1955 PITTWATER ROAD, BAYVIEW

S4.55 AMENDED PLANS

DRAWING LIST

Drawing Title
 Tree Retention Plan

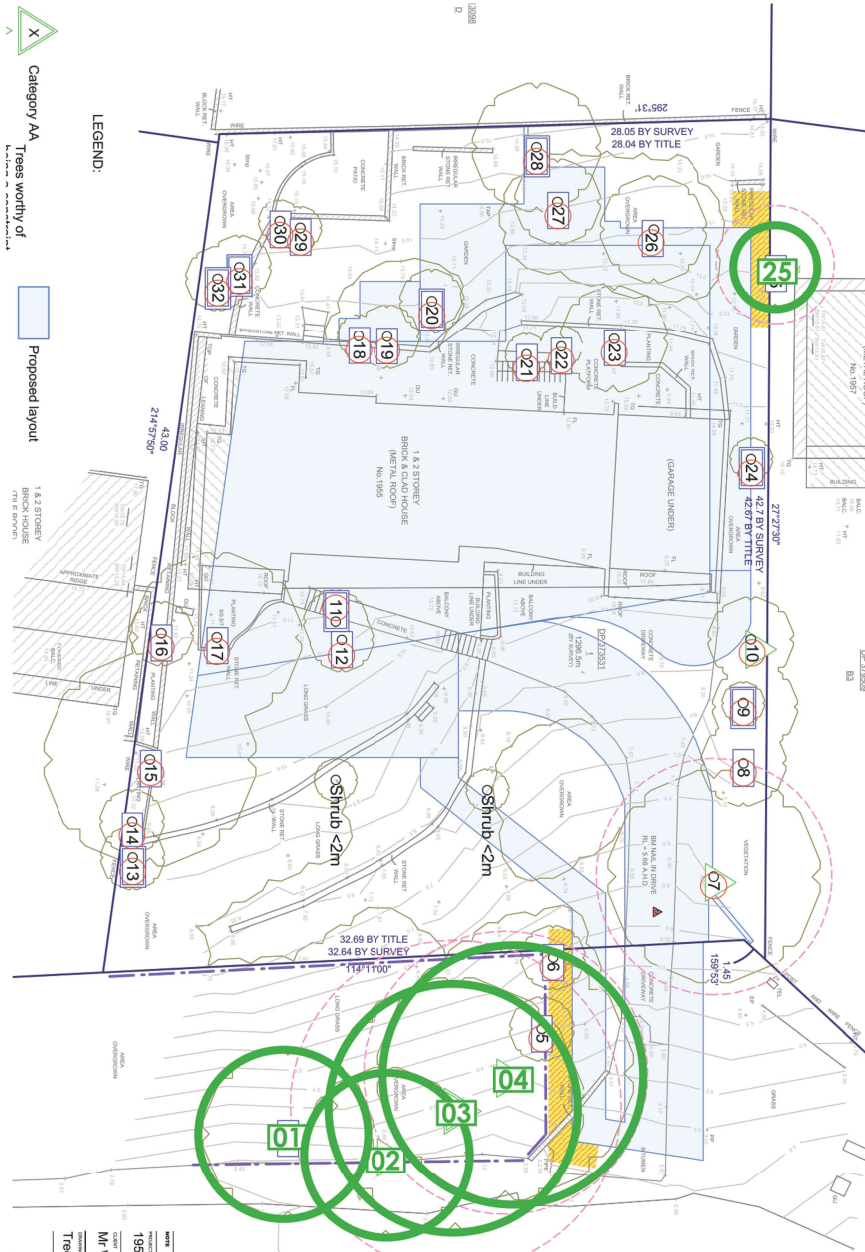
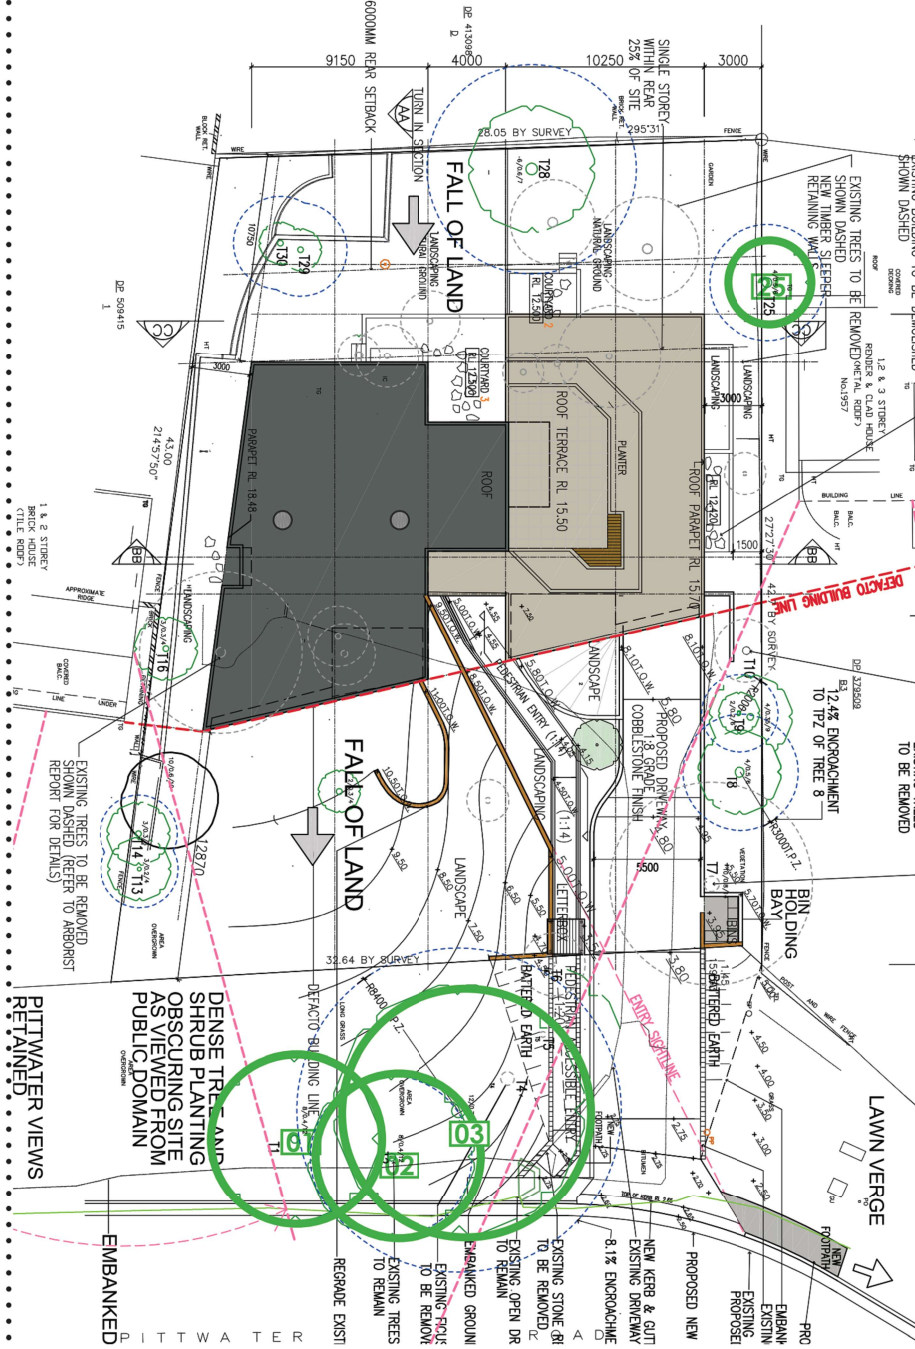
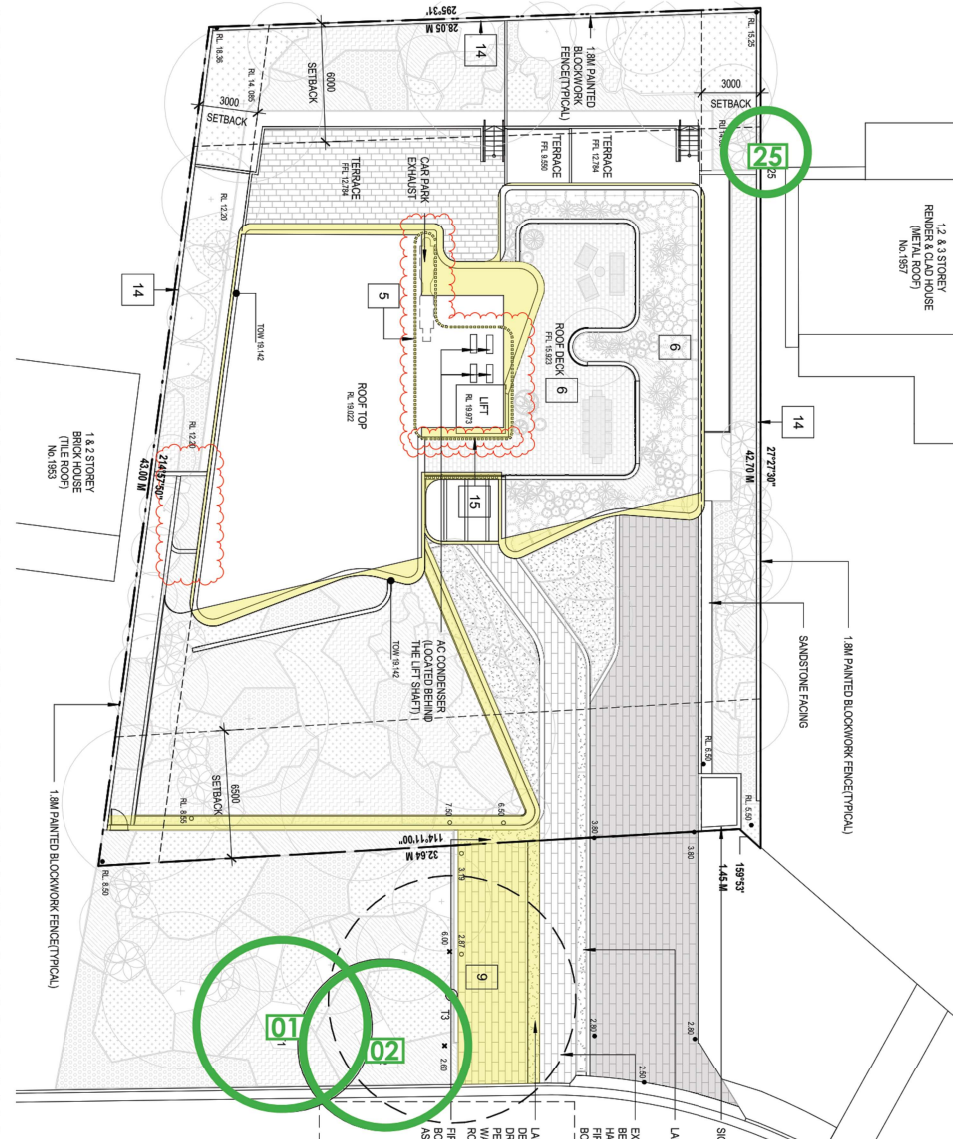
9. FRNSW Requirement - to provide hardstand & fire hydrant booster assembly , requiring removal of tree T3 (Refer to Arborist Report).

Drawing Title
New/ Replacement Tree Plan

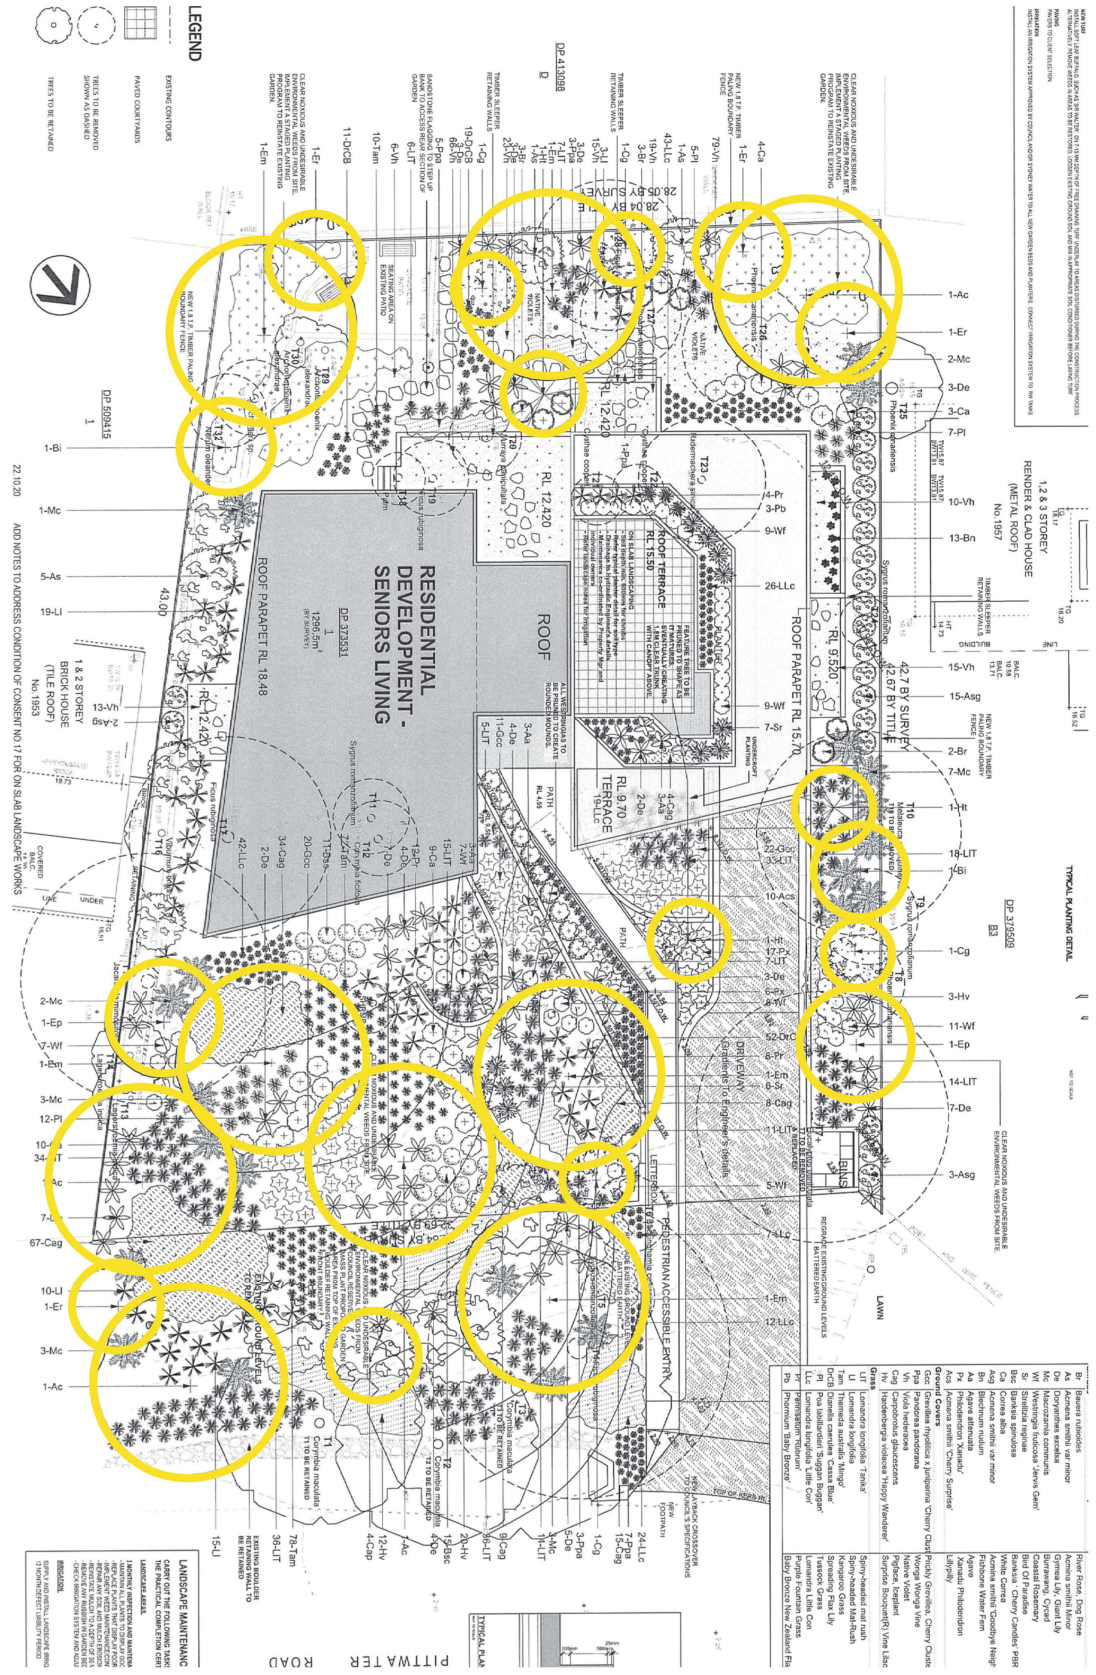
DA2021/0343
APPROVED
(ADDITIONAL 28 TREES)

CURRENT PROPOSAL
(ADDITIONAL 35 TREES)
